**Re: Jackson Hydroelectric Project, FERC No. 2157
Operation Compliance Monitoring Plan WY 2024-2025 Annual Report
License Article 407**

Operation Compliance Monitoring Plan Annual Report for Water Year July 2024 – June 2025 *(License Article 407)*

RE: Department of Ecology comments on the Operation Compliance Monitoring Plan Draft Annual Report for Water Year July 2024-June 2025 (License Article 407) for the Henry M. Jackson Hydroelectric Project, FERC No. 2157.

Table 1. Process Flow Log, July 2024 – June 2025.

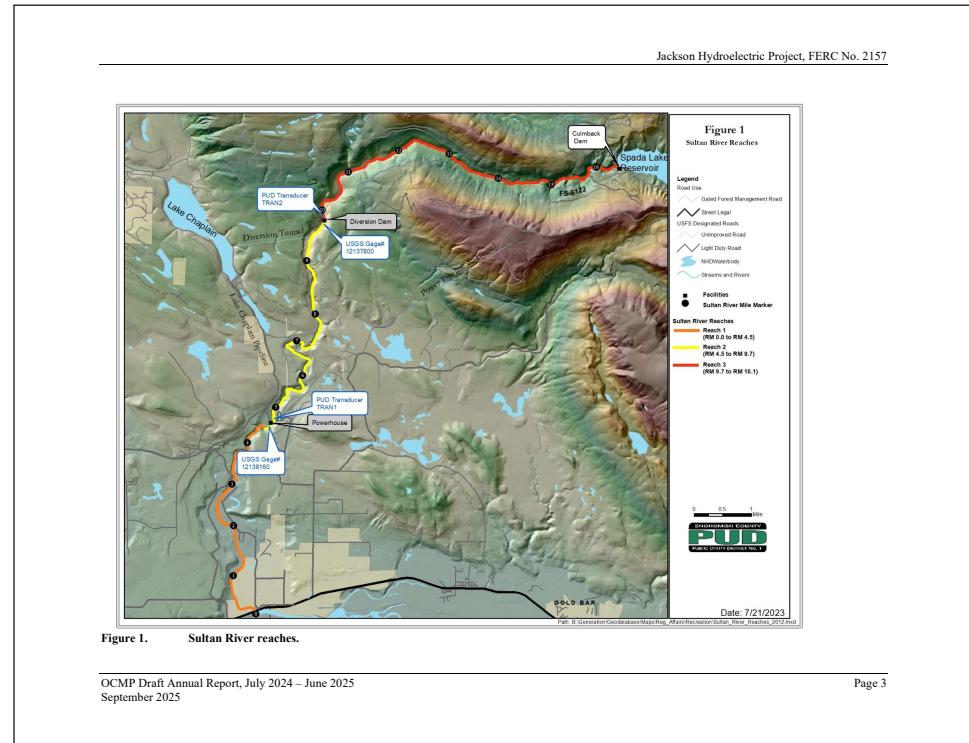
[Author: sboh461 Subject: Comment on Text Date: 9/5/2025 2:41:20 PM]
Is it possible to include a column that includes frequency requirements, number of flows, and if you have met or exceeded the requirements?

[Author: sboh461 Subject: Comment on Text Date: 9/5/2025 2:56:54 PM]
Thank you for including the reach abbreviation in this column. The flow measuring points change depending on the reach. IE - R2 is immediately upstream at RM 4.7, while R1 is at the USGS gage 12138160. The monitoring location is included in the charts below which is helpful. It may be useful to include a description of the monitoring locations above this table, as some reviewers may be confused as to the different locations described in the charts.

[Author: sboh461 Subject: Comment on Text Date: 9/5/2025 2:39:27 PM]
This one is interesting. It started out and ended above the minimum at 300 CFS? Are these flows tied to a natural event?

[Author: sboh461 Subject: Sticky Note Date: 9/5/2025 2:39:43 PM]
As an upmigration flow, are there any upper limits, or higher flow volumes that would be considered a (velocity) barrier in any constricted portions of the river?

[Author: sboh461 Subject: Comment on Text Date: 9/5/2025 1:44:05 PM]
Anne - Do you think this should be defined or included before the table?

4	Table 1. This one is interesting. It started out and ended above the minimum at 300 CFS? Are these flows tied to a natural event?	A planned maintenance shutdown was in effect during this event. All minimum instream flows were met from valve releases at Culmback Dam.
5	Table 1. As an upmigration flow, are there any upper limits, or higher flow volumes that would be considered a (velocity) barrier in any constricted portions of the river?	Based on previous hydroacoustic data (2018-2021) flows exceeding 300 cfs limit upstream migration through the Diversion Dam sluiceway. (<i>Snohomish PUD. 2022. Sonar Monitoring of Steelhead Trout and Chinook Salmon at the Sultan River Diversion Dam, 2018-2021.</i>)
6	Table 1 footnote. Do you think this should be defined or included before the table?	The various component flows are now defined in detail in Appendix B.
